Hydrol. Earth Syst. Sci. Discuss., https://doi.org/10.5194/hess-2017-377-AC1, 2017 © Author(s) 2017. This work is distributed under the Creative Commons Attribution 4.0 License.

Interactive comment on "Contaminant source localization via Bayesian global optimization" by Guillaume Pirot et al.

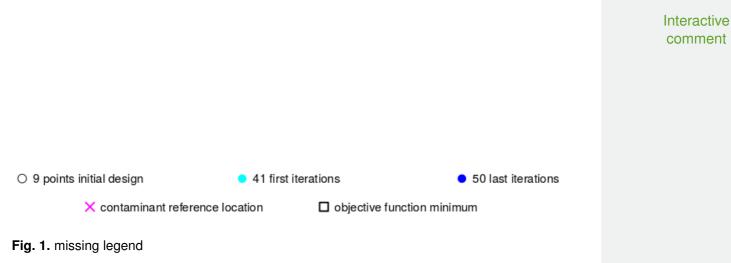
5, The dots in Figure 5 are with three different colors, and you just explained the meaning of blue and white dots. Please explain the left one.

Indeed, a part of the legend is missing. The following legend (Fig. 1 of this answer) will be added to the figure.
